SITE PLAN REVIEW

Project Name: Duplex

FILE # 139-94

TITLE HEADING: Site Plan Review - Duplex

SITE & LANDSCAPING PLAN for DUPLEX
 2441 BULLTICK AV. GR., K.T. CO.

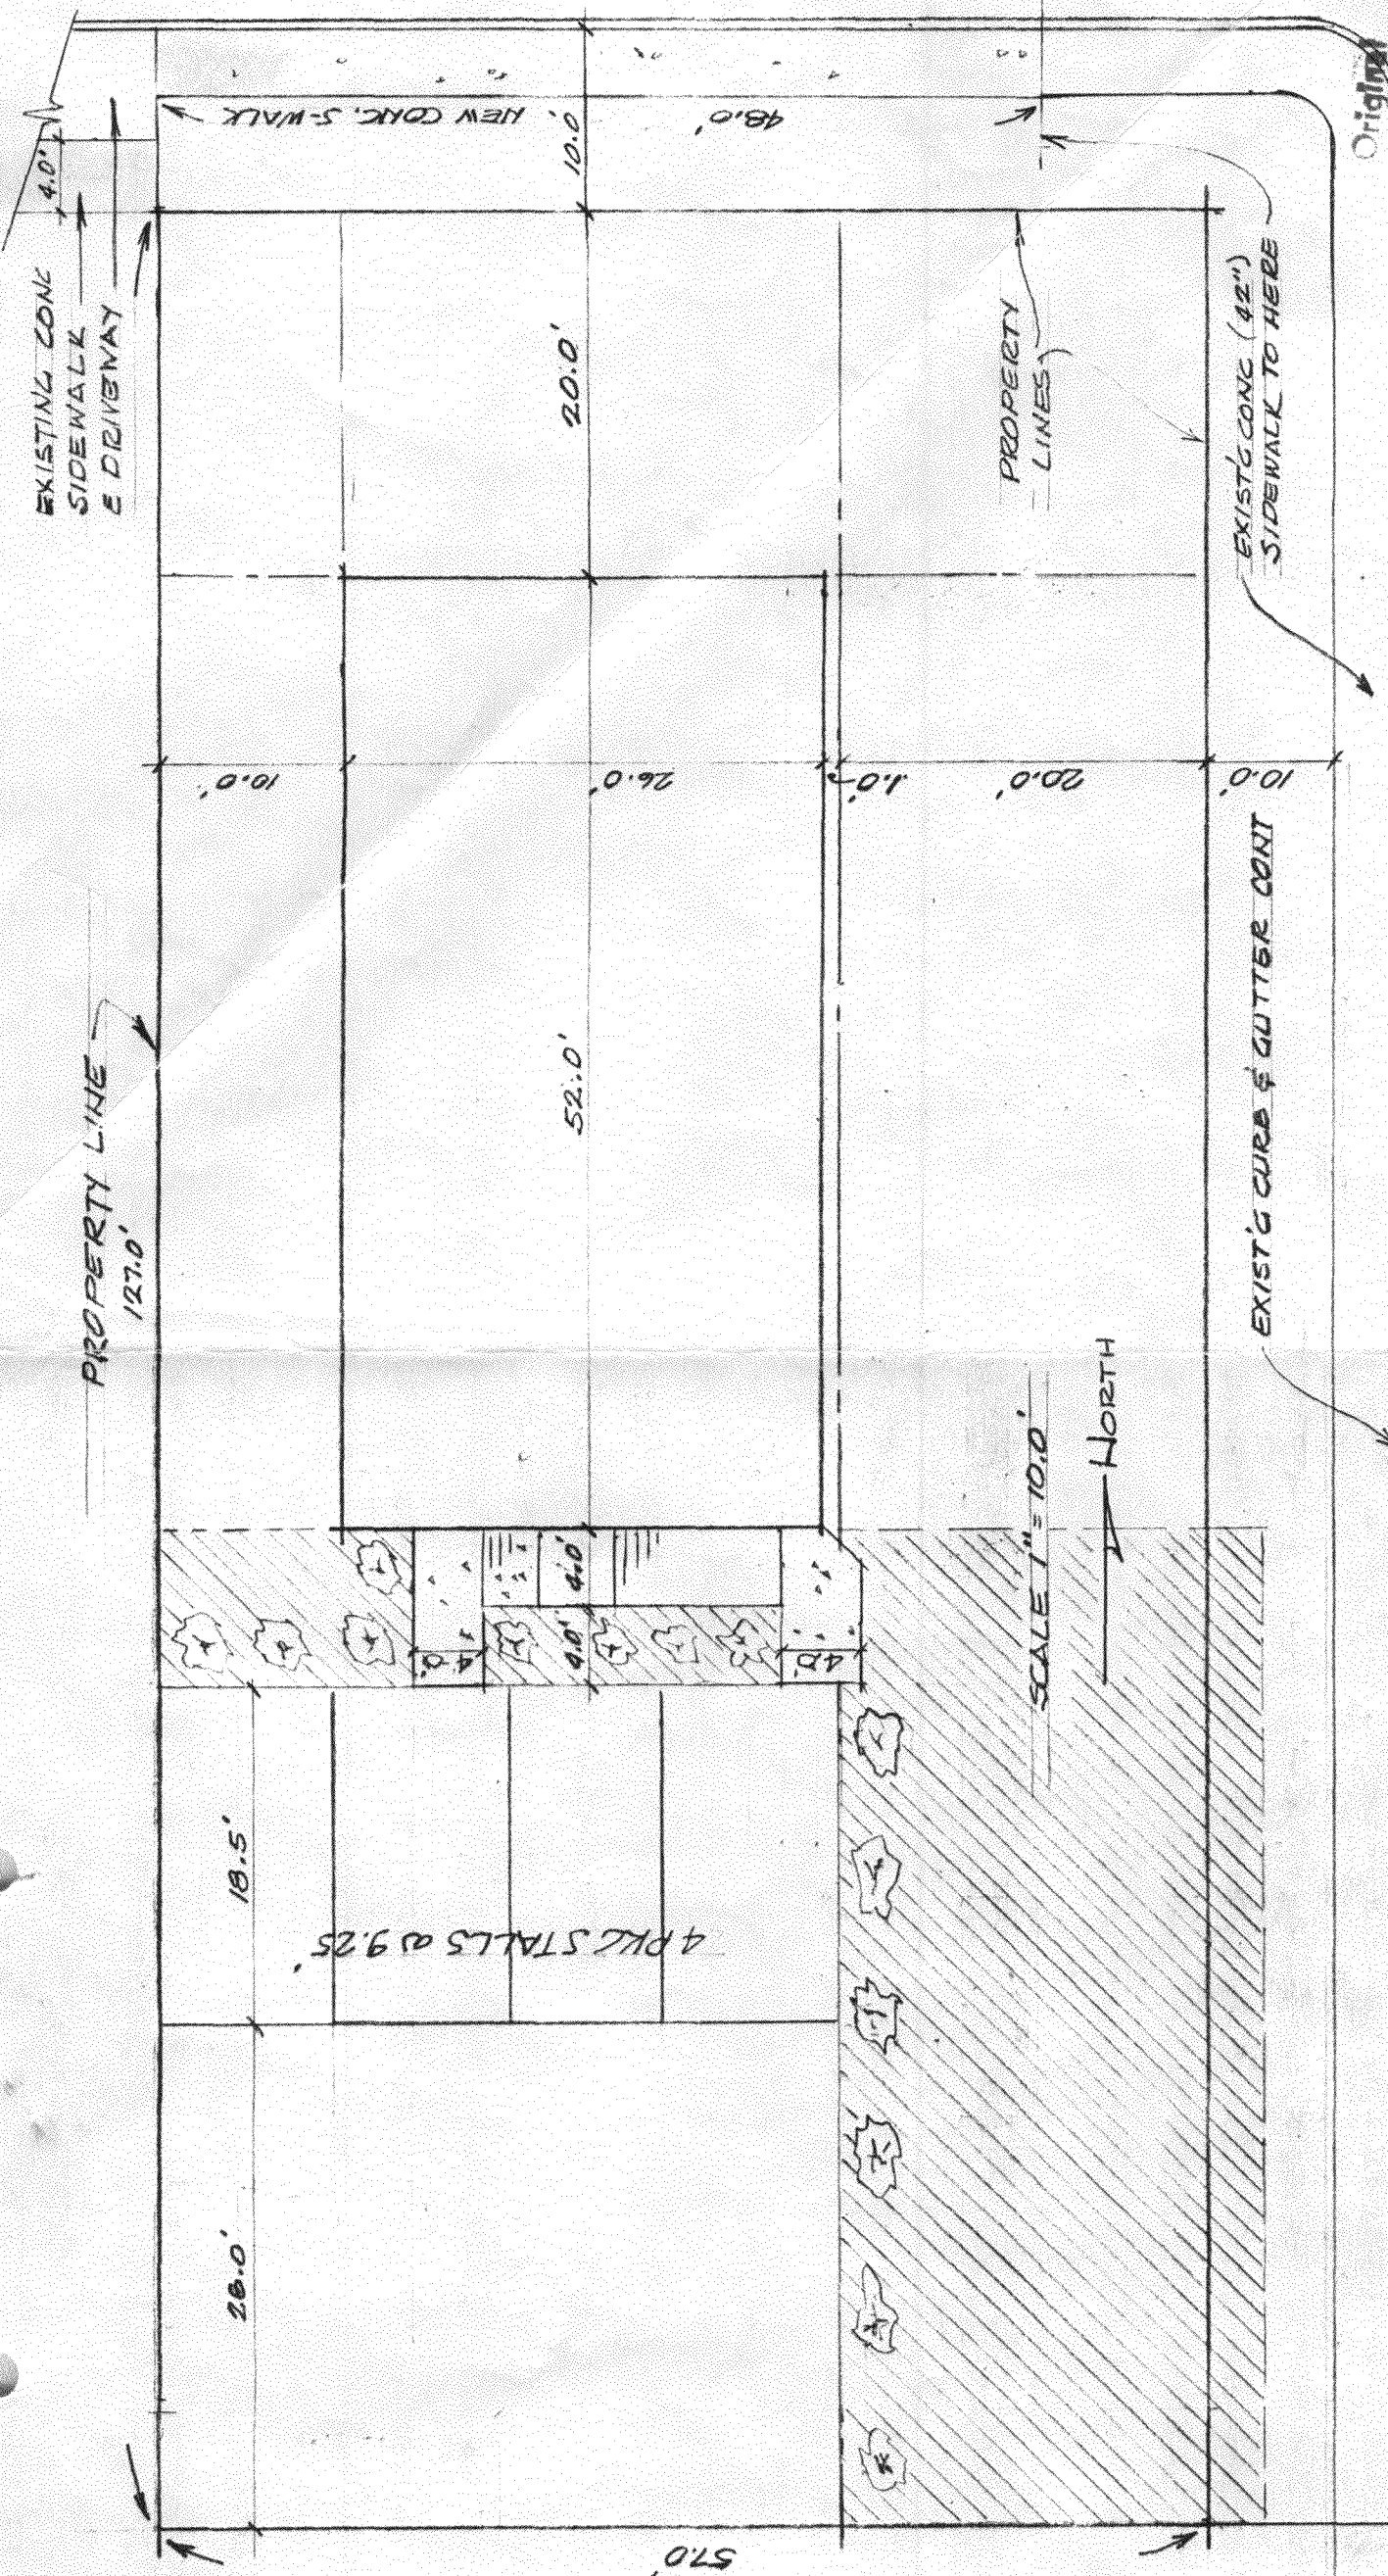
The new sidewalk must transition into the existing sidewalk at 45 degree angle for continuity. The cost of this will be credited toward the \$800 TCP.

1. The plans shall be revised to add the following statement "An underground, pressurized irrigation system shall be provided for all landscaped areas."
2. As per Section 5-4-15A of the Code the applicant shall provide one tree per each 500 sq. ft. of required landscape area.
3. The provided landscaping does not meet Code requirements. As per Code (copy attached), forty (40) percent of the landscaped areas shall contain shrubs, and the shrub areas shall be covered by a minimum of 75% plant material. Staff may waive part of the shrub and tree requirement if the applicant provides a seeded grass surface for the entire lot area.
